<b>AMENDMENT OF SOLICITATION/MODIFICATION OF CONTRACT</b>				1. CONTRACT ID CODE		PAGE OF PAGES 1   2	
2. AMENDMENT/MODIFICATION NO. 01		3. EFFECTIVE DATE 08-Feb-2023		4. REQUISITION/PURCHASE REQ. NO.		5. PROJECT NO (If applicable)

0001 Amendment 01.

**CLEVELAND, OHIO  
CLEVELAND HARBOR  
DREDGING  
FY23**

**CONTRACTOR QUESTIONS,  
GOVERNMENT REPLIES,  
UPDATED PLANS,  
AND SPECIFICATIONS**

SHEET ID
C-101

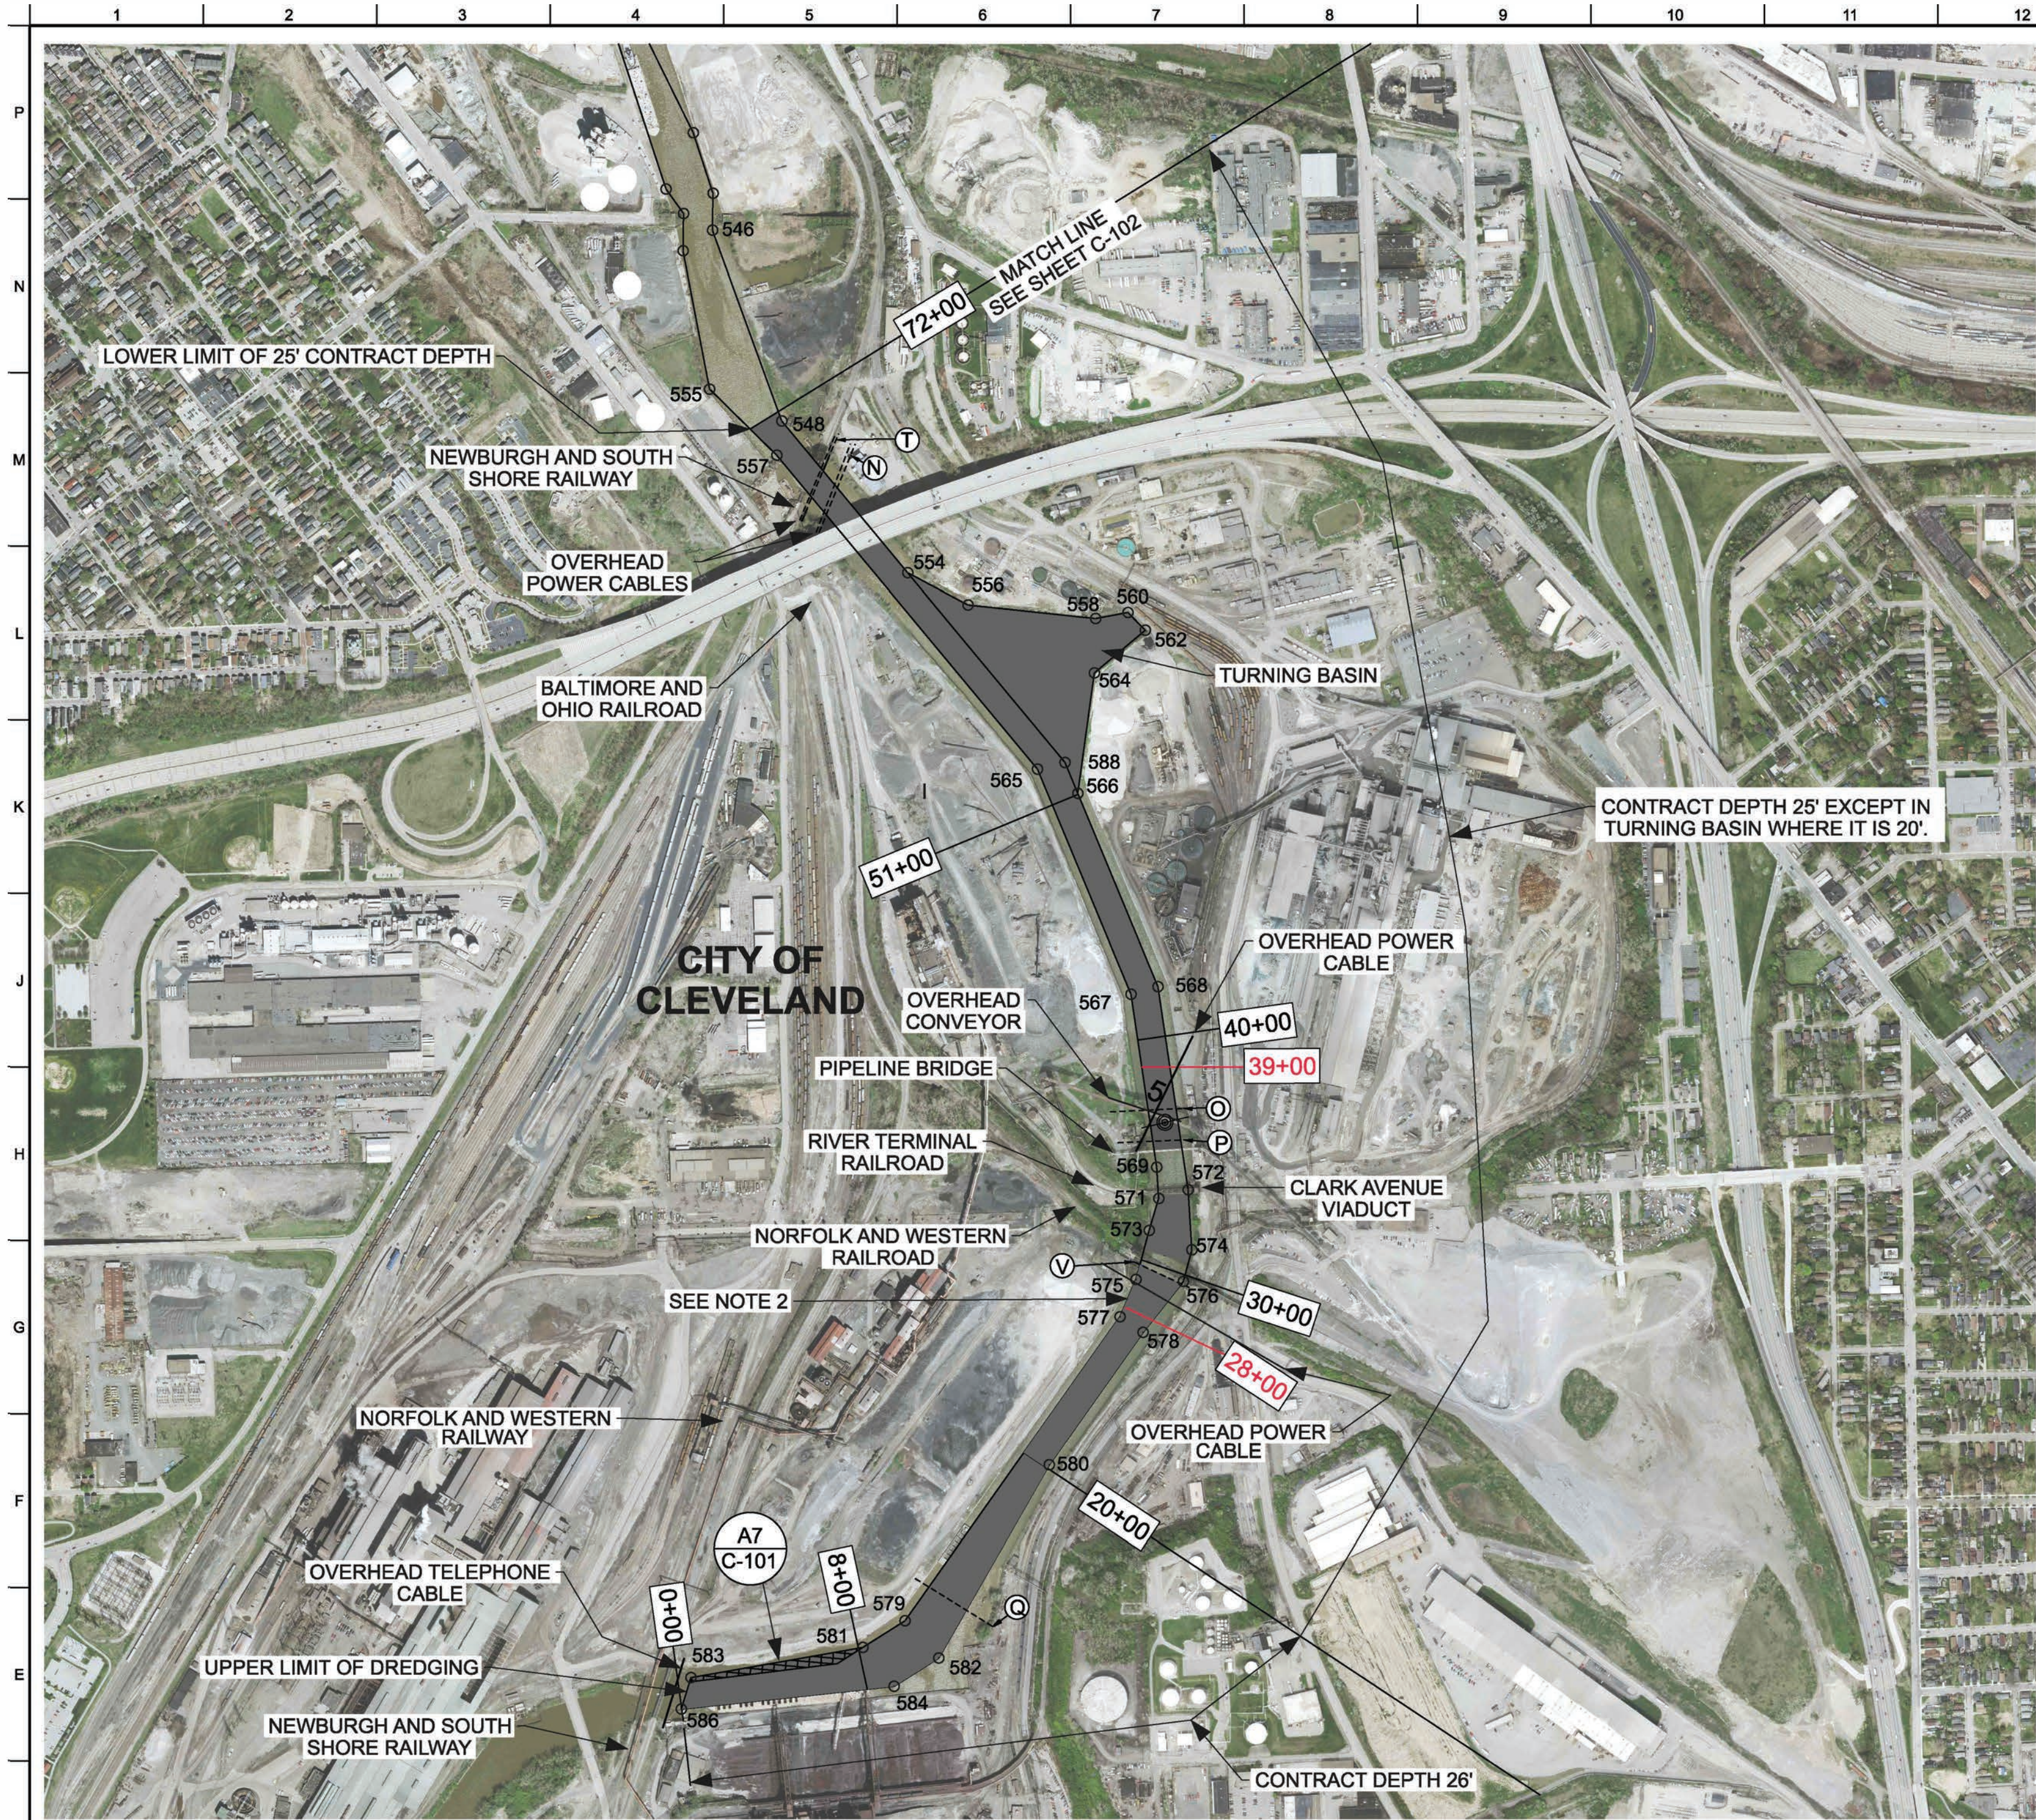
- 5.) SHT C-101, Note 2.B States Stations 28 – 39 are a separate bid item on the bid form? Please clarify bid form?

a. Sheet C-101

(1) Notes 2.B has been been deleted.

Response: This will be addressed via amendment, with the drawing revised to delete this note.
